Application for Certificate of Appropriateness for Design Review

*Site Address 4251 Johnstown Road

Project
FMC Medical Clinic
Gahanna (#3995-1)
4251 Johnstown Road, Millin Twp, Franklin County, Gahanna, Ohio
Sheet Title
Site Development Plan
Design Review & Final Development Plan

PLAN REVIEW

Sheet No.
C301
6 Civil Sheets

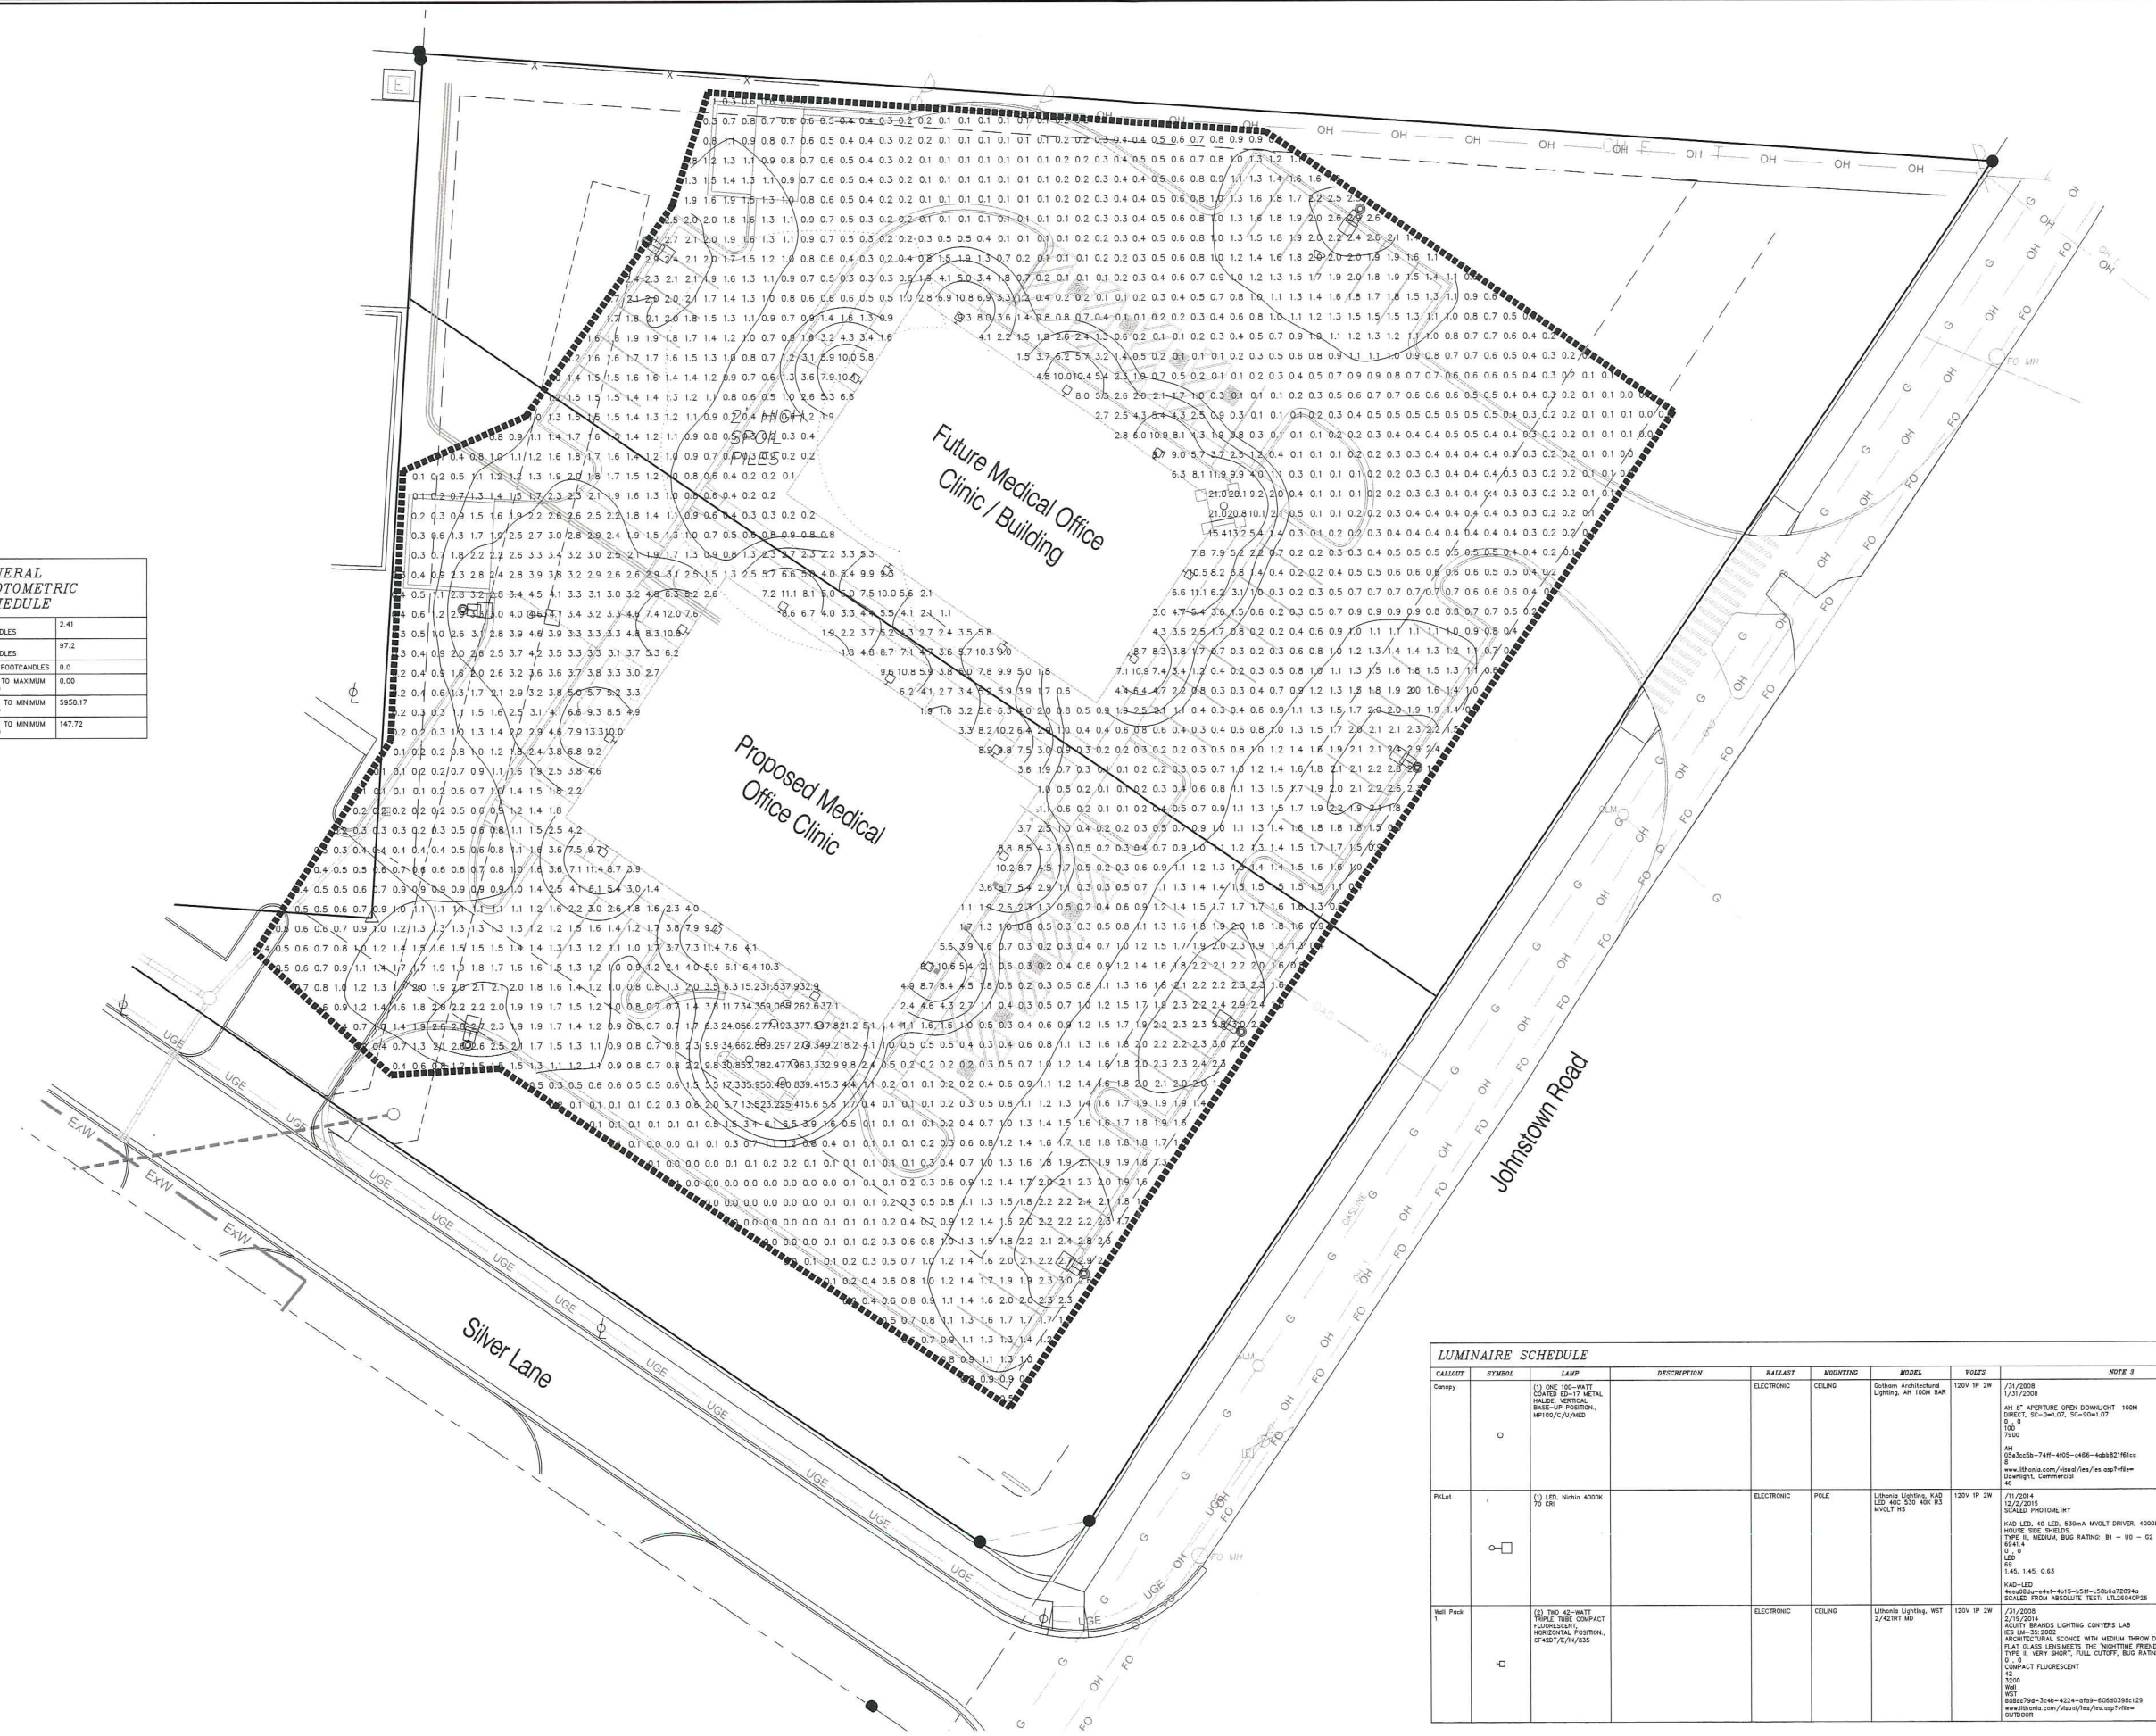
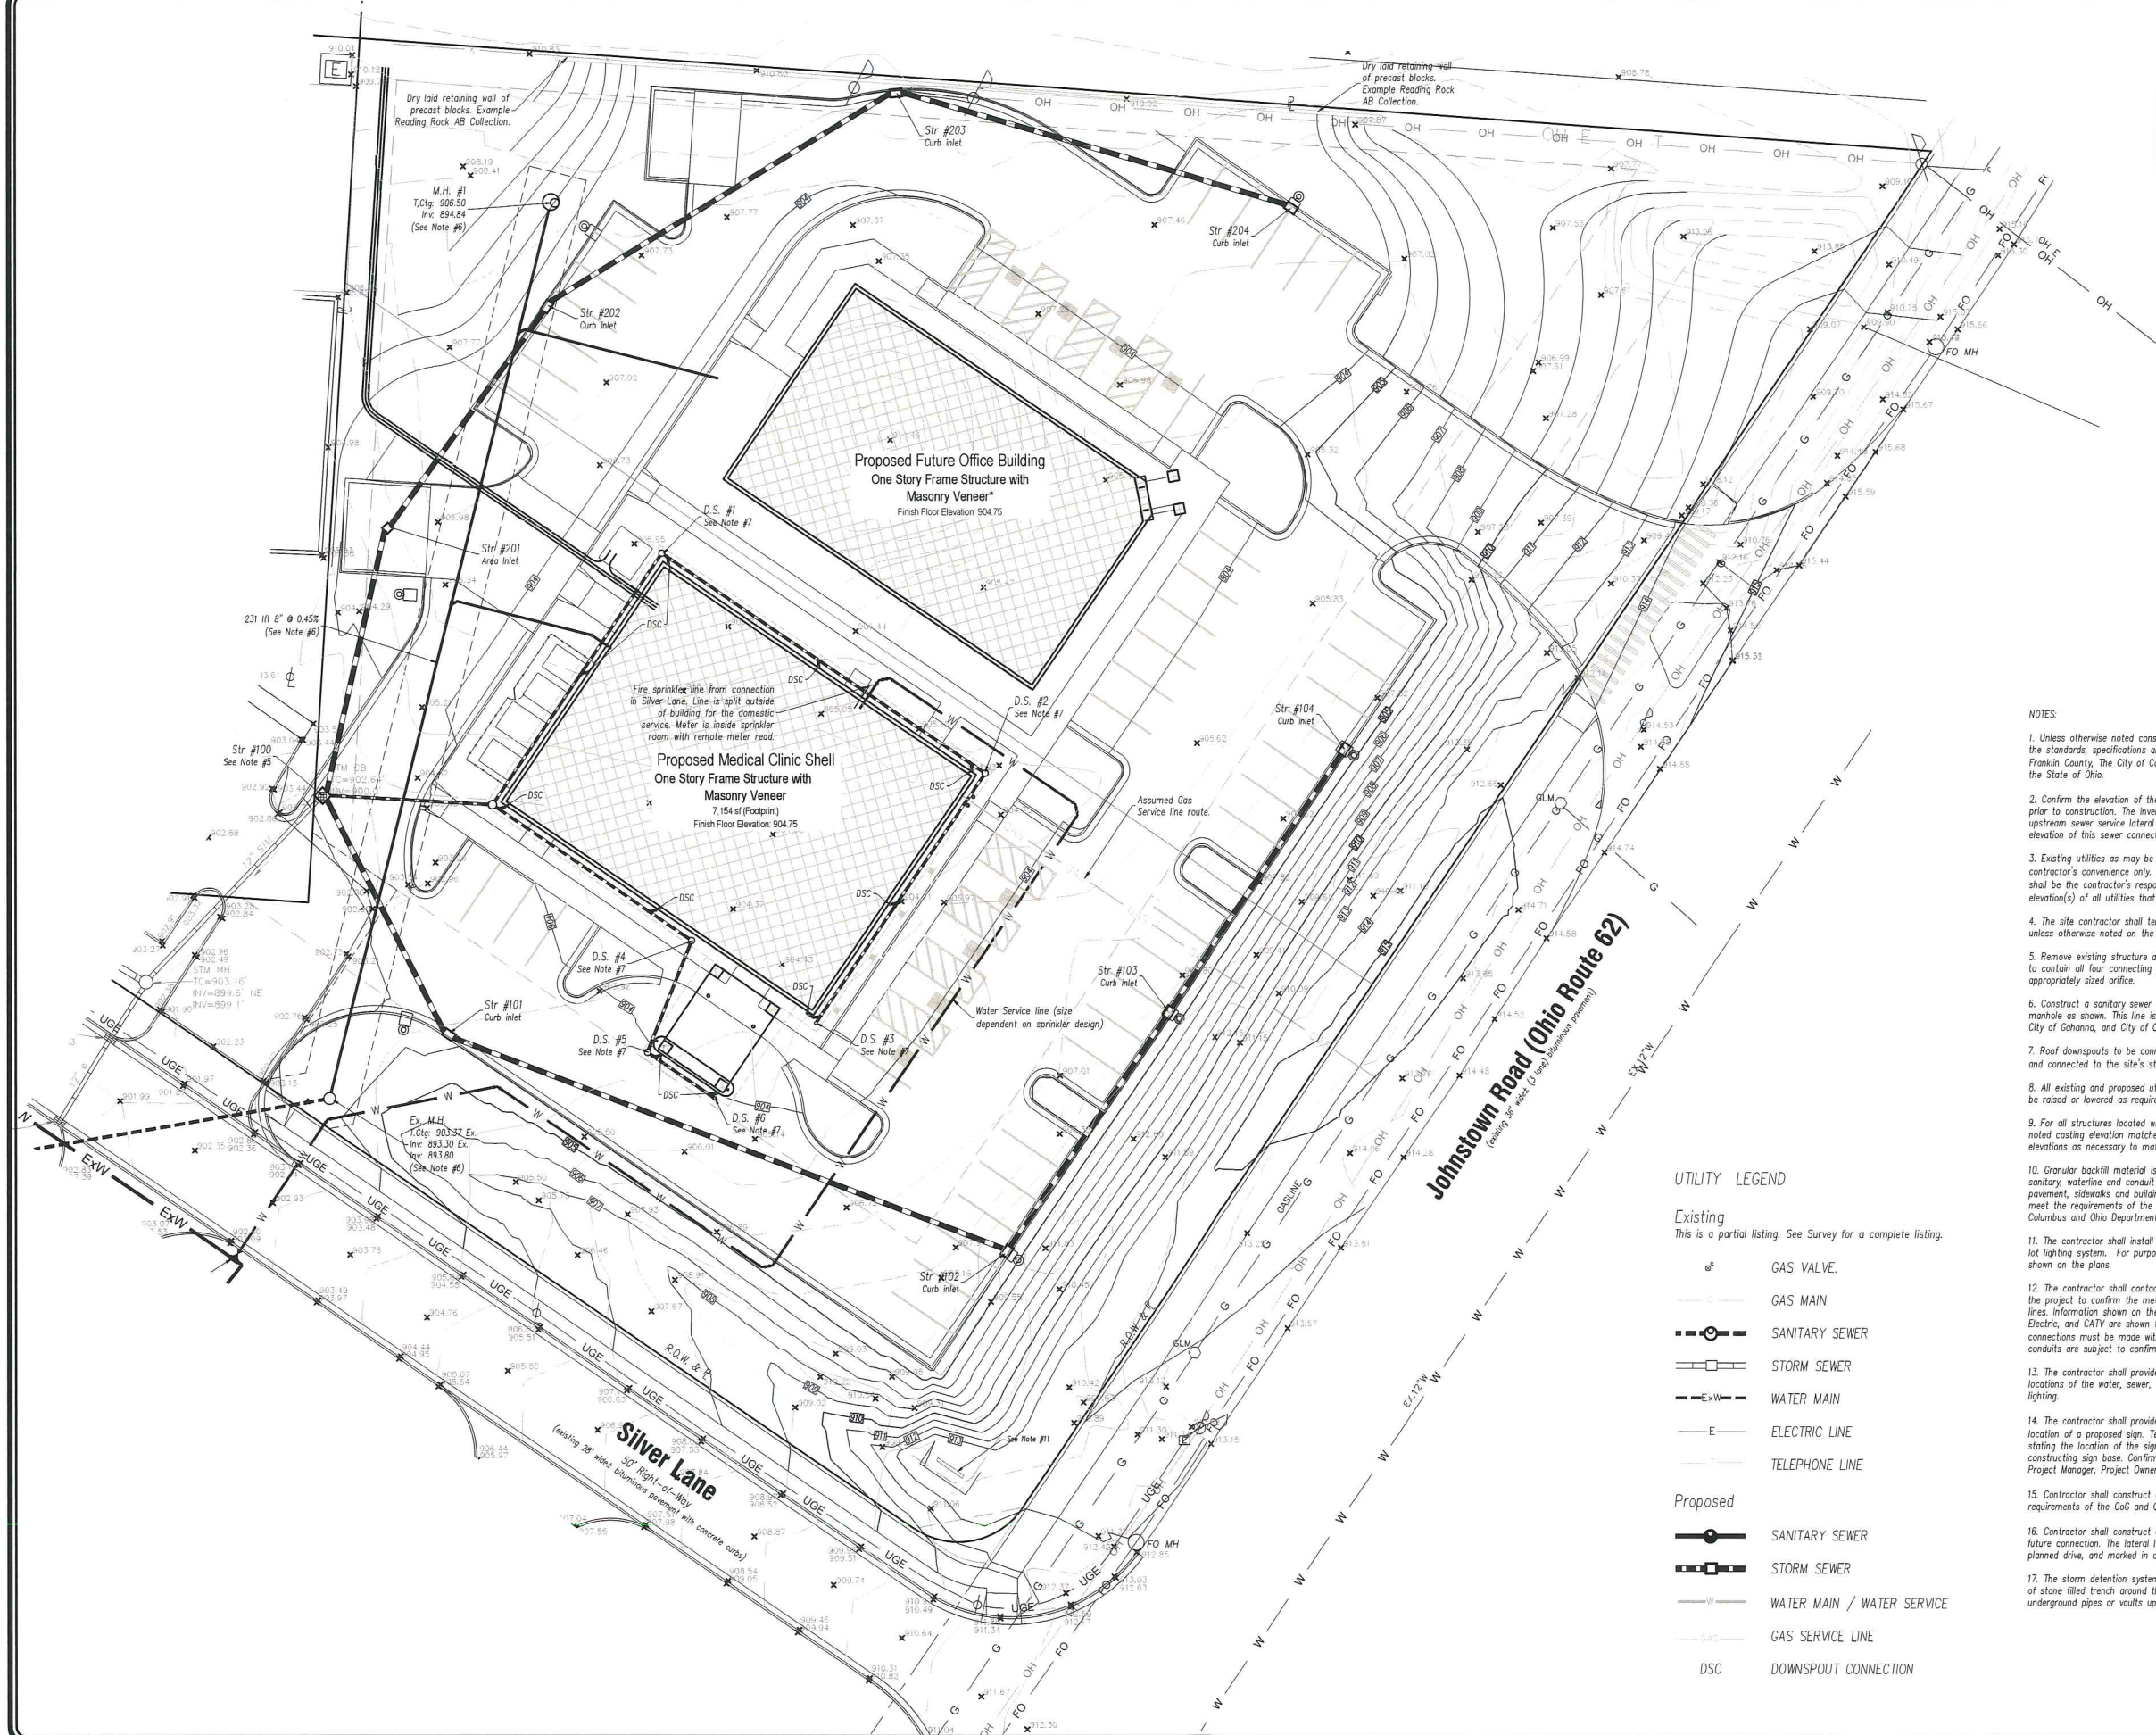
ISSUE: The fire hydrant locations were not on the plan, but the size of the building requires 1750 gpm if it is a II B structure and 2250 gpm if it is a V B structure. It does show a sprinkler room on the plan and if it is sprinklered, 1500 gpm is the required fire flow for the building.
